September 22, 2015

RE: Submittal of Response to EPA and TCEQ July 2015 Comments on Feasibility Study
Patrick Bayou Superfund Site – Deer Park, TX

Aug 31, 2015 5:17pm tgriga K:\Projects\0284-Patrick Bayou Joint Defense Group\Patrick Bayou 2013\0284-RP-012_PELQ_307.dwg Exhibit 5

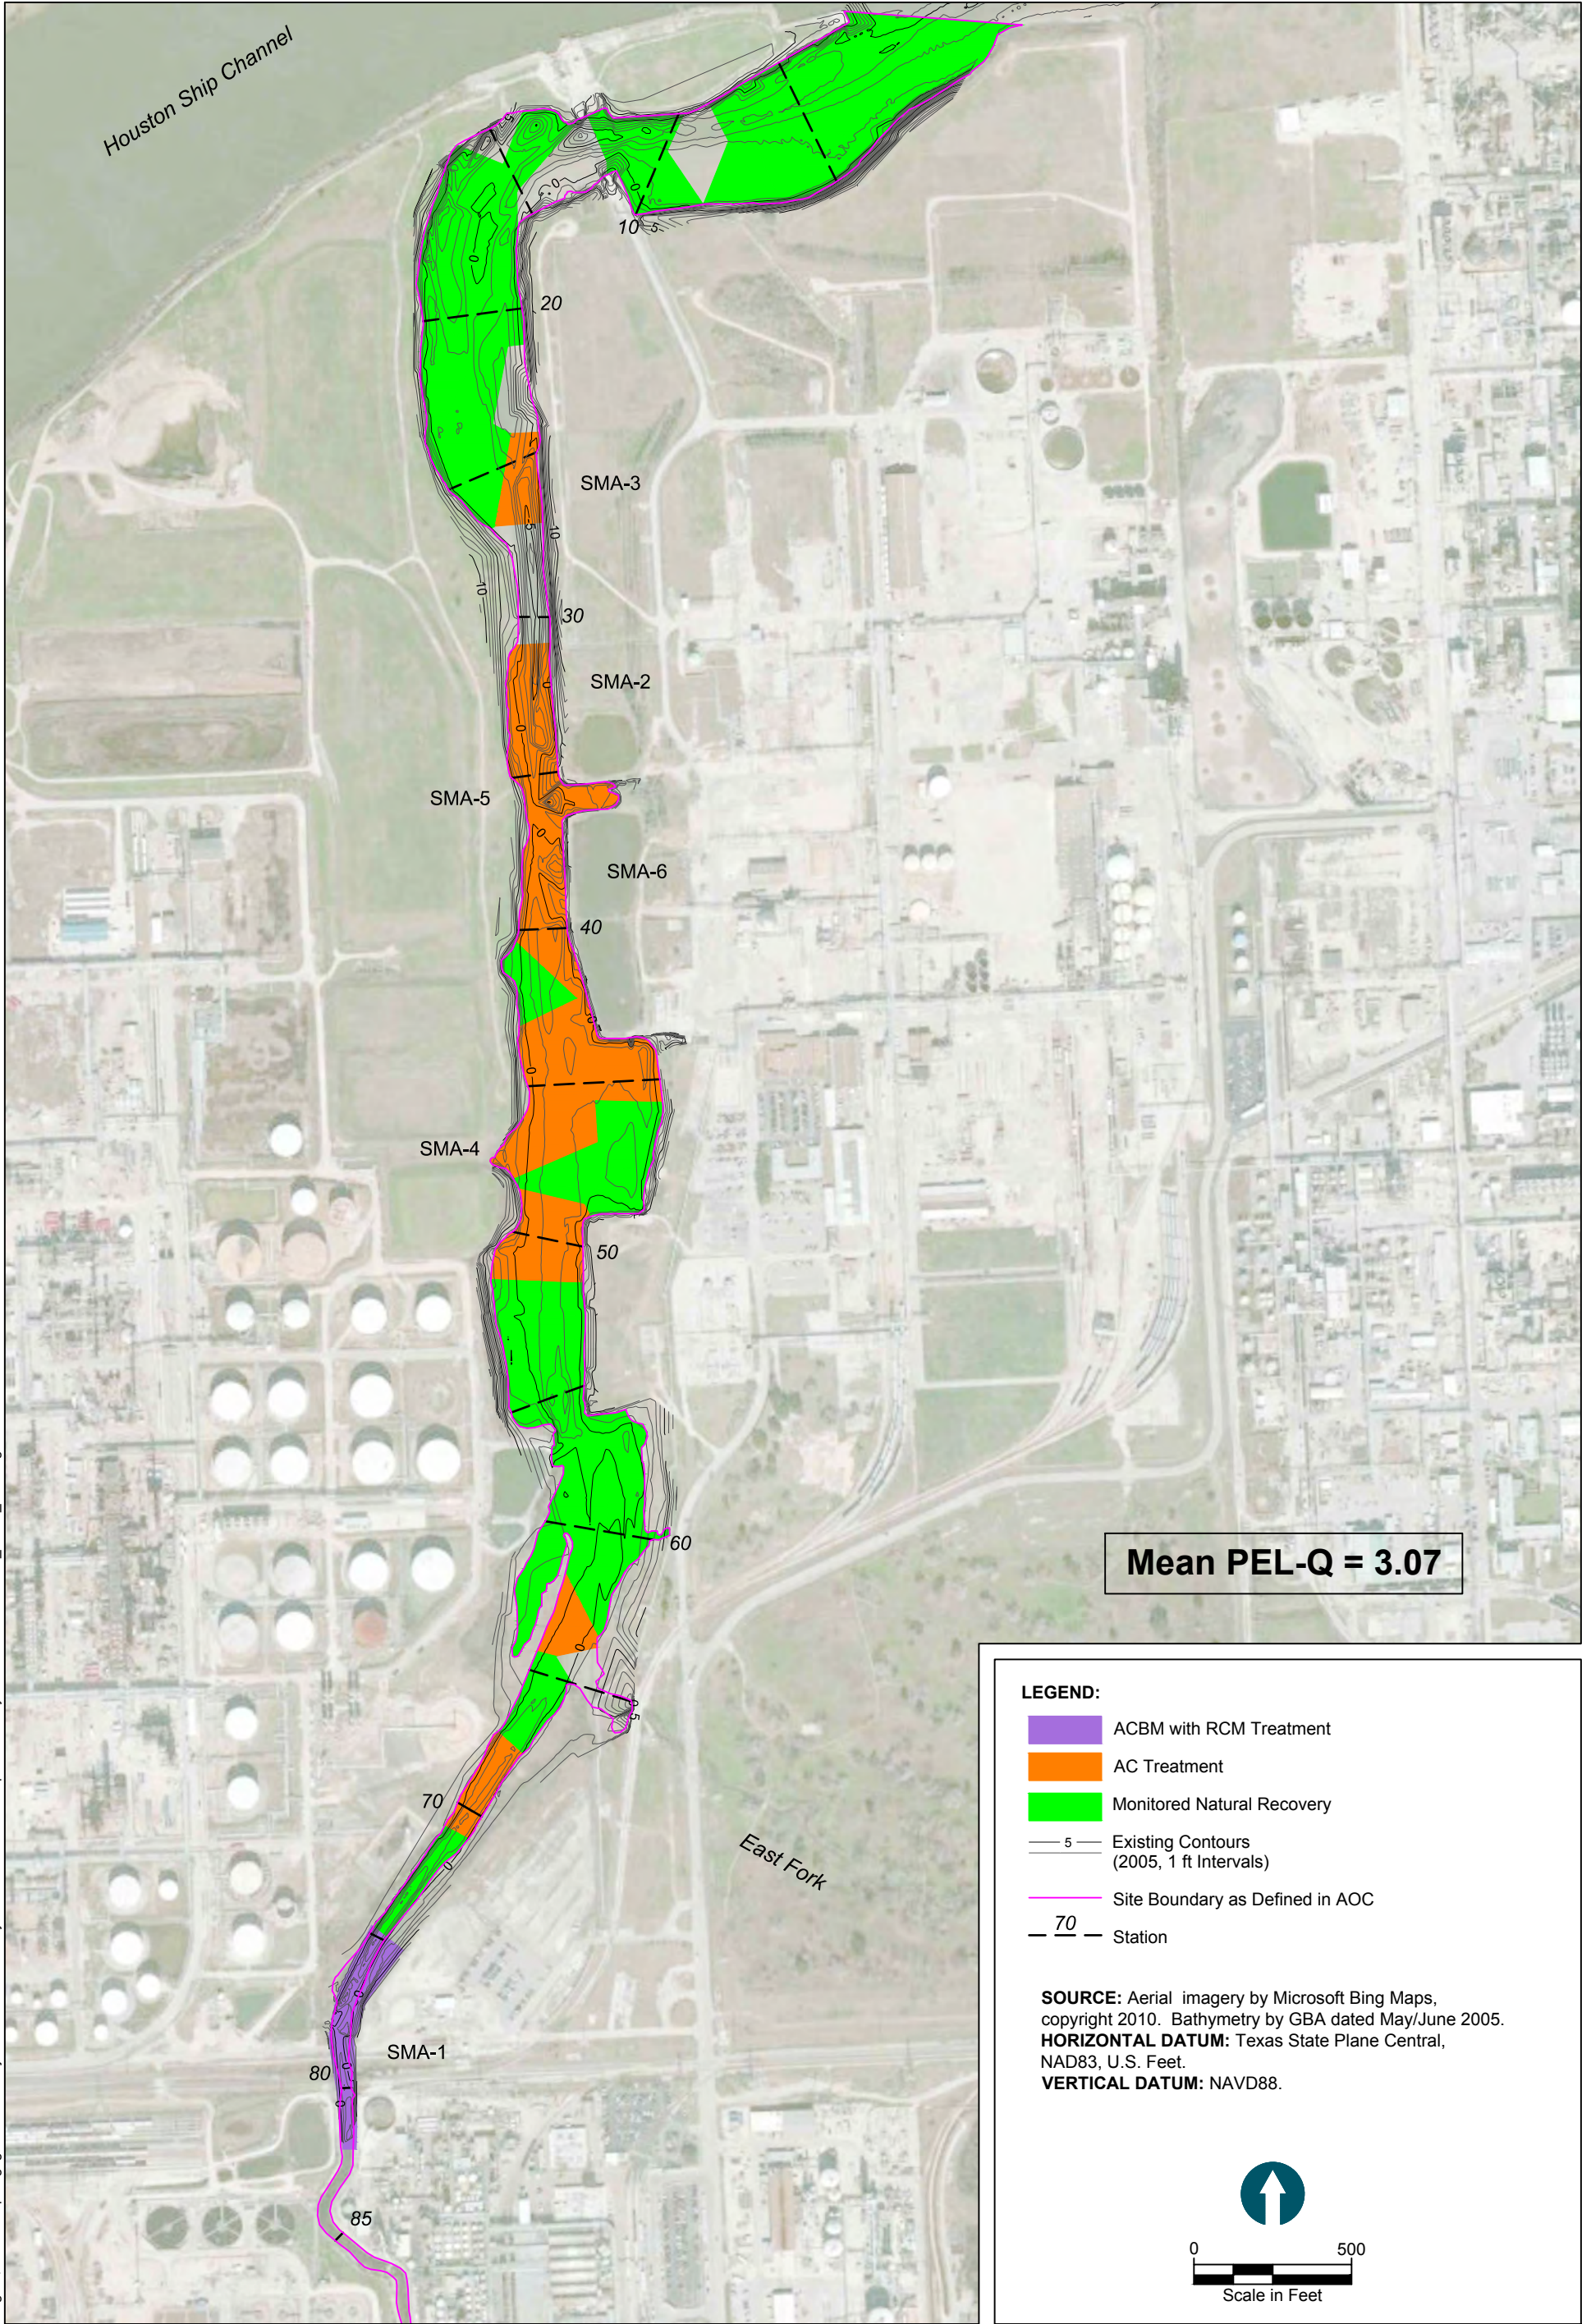
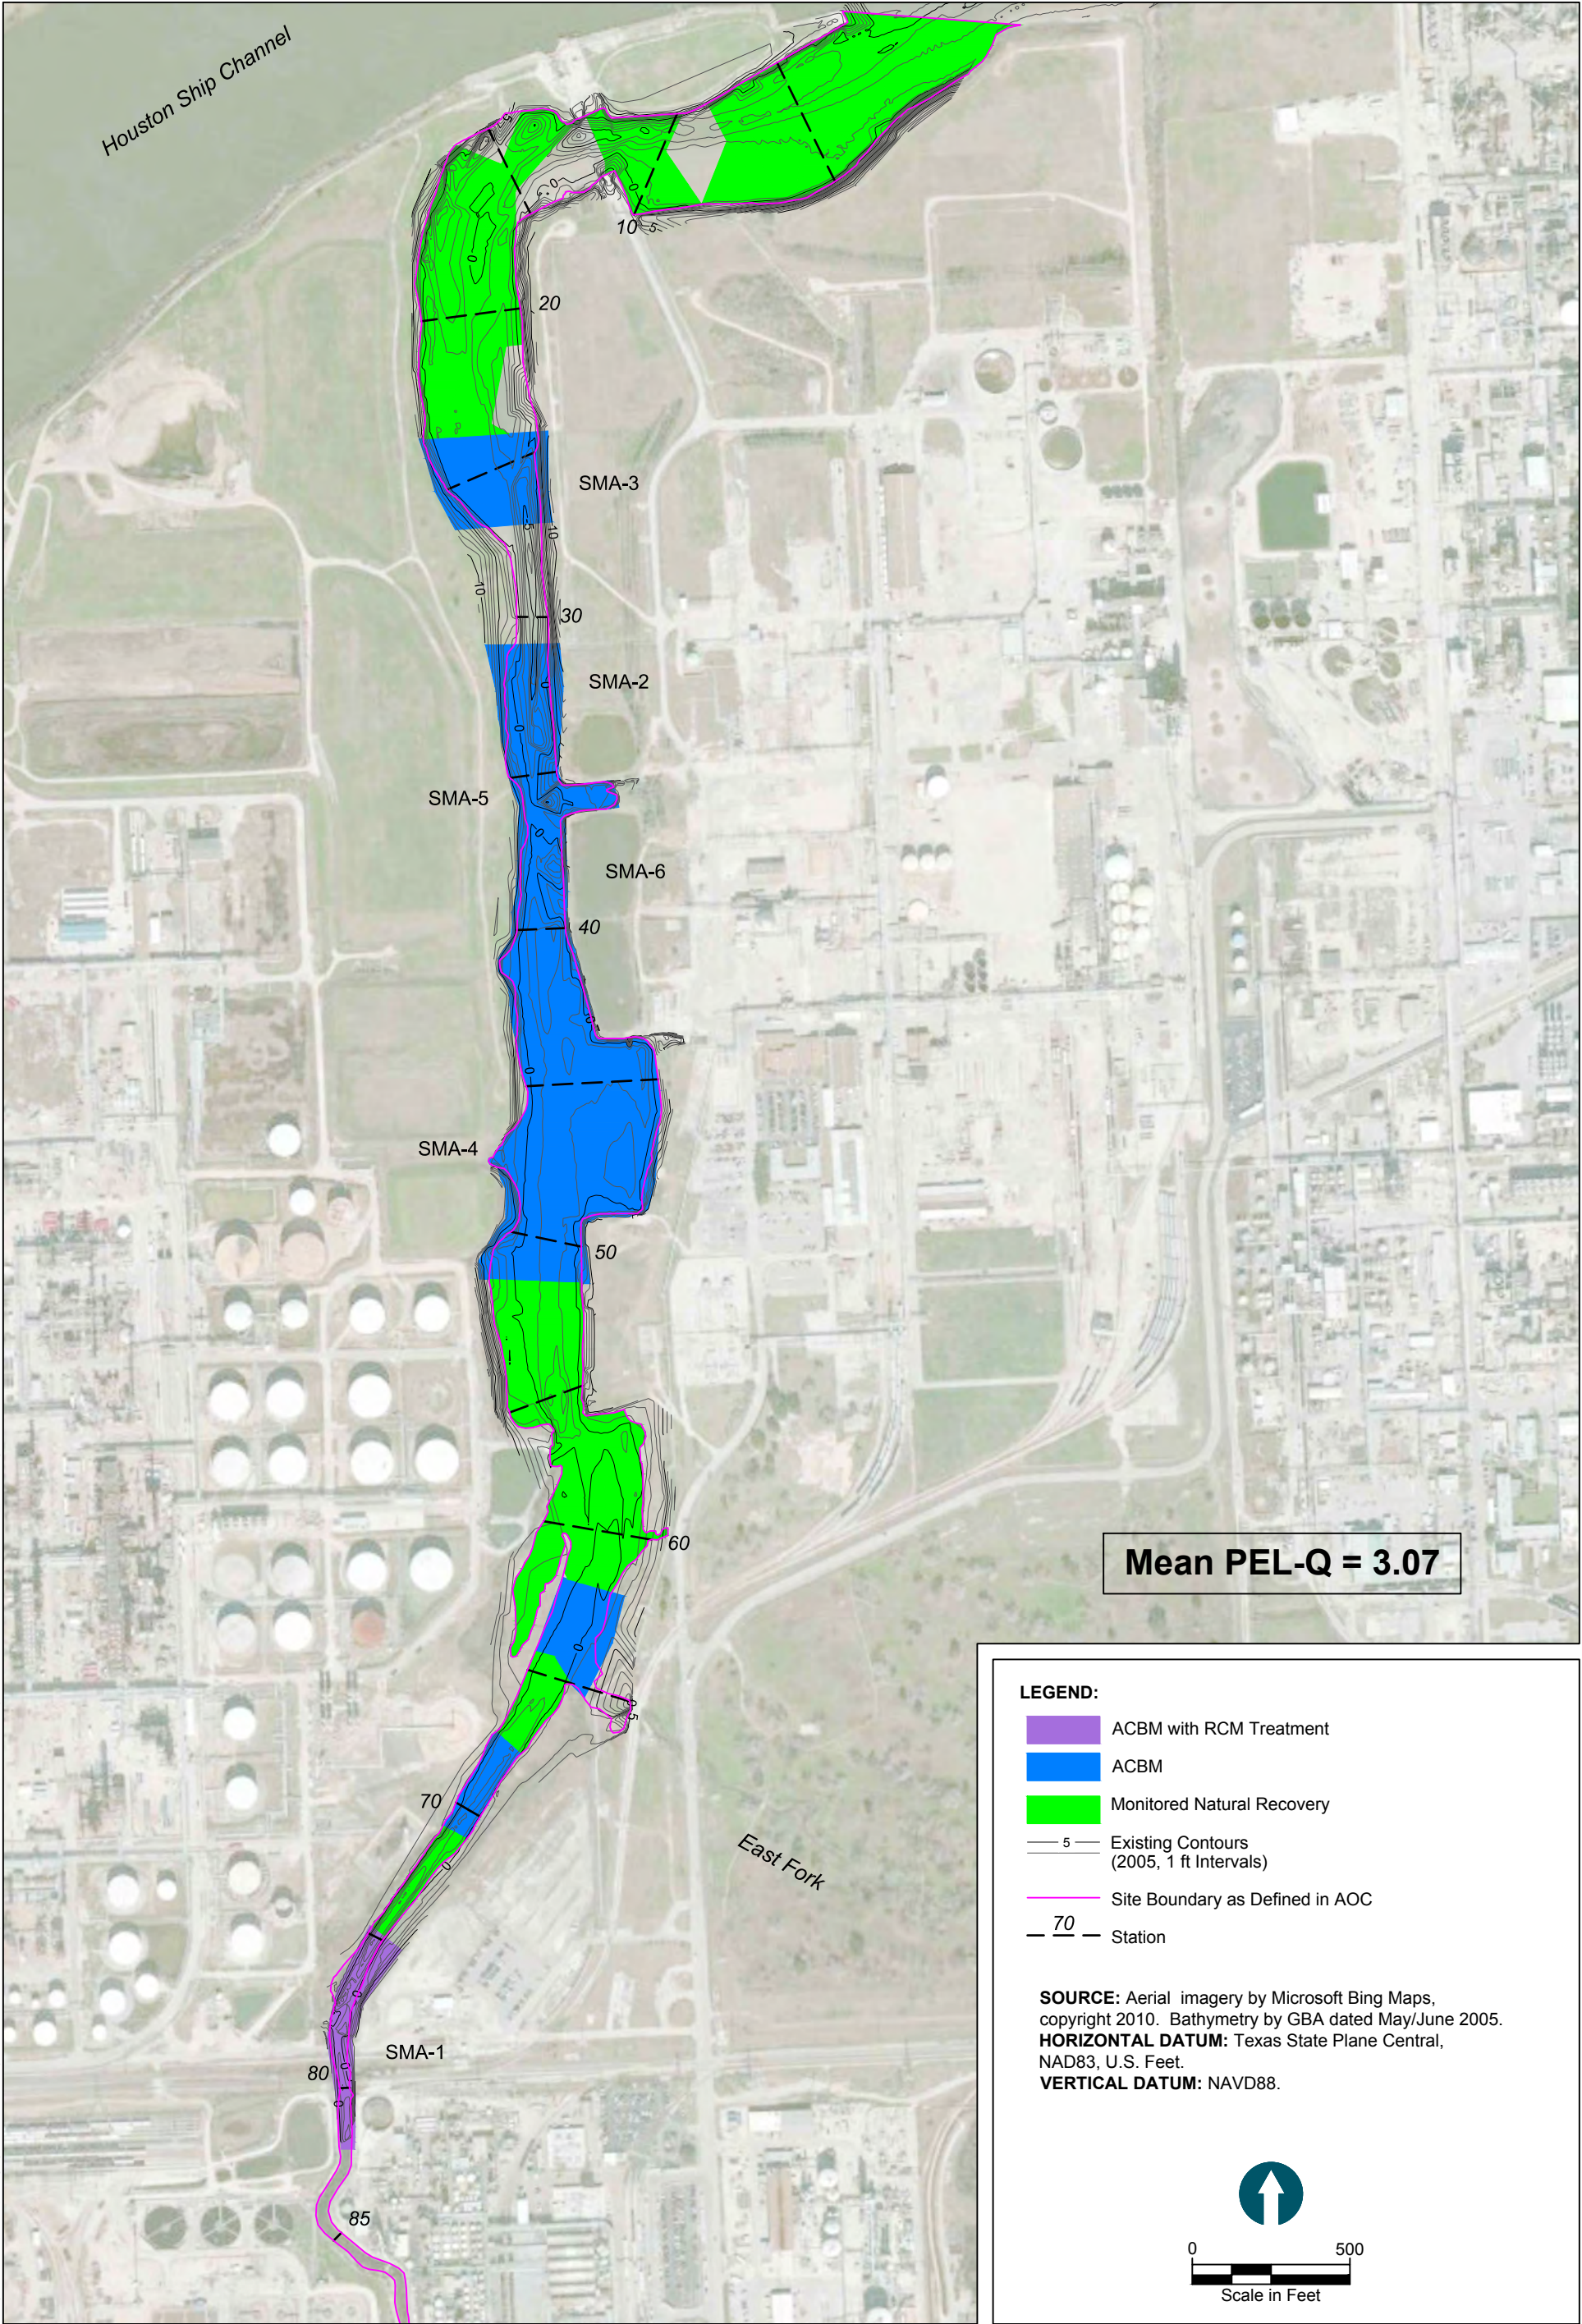
Second, the probable effects level quotient (PEL-Q) issue has not been resolved. While we prefer a target PEL-Q value of 3.07, we are willing to consider the compromise PEL-Q value of 4.47, depending on our evaluation of the additional information requested below.	As previously documented, the probable effects level quotient (PEL-Q) value of 3.07 is not supported by the data or analysis presented in the U.S. Environmental Protection Agency (USEPA)-approved Baseline Ecological Risk Assessment (BERA). TCEQ’s comments on the Draft Feasibility Study (FS) Report dated December 19, 2014 states a preference for the sediment preliminary remediation goal (PRG) to be set at a mean PEL-Q of 3.07 to represent the lowest mean PEL-Q for any station

⁹ Note that, consistent with the above response regarding the applicability of the mean PEL-Q of 3.07 as a sediment target value, Exhibits 5 and 6 are provided for comparison only.
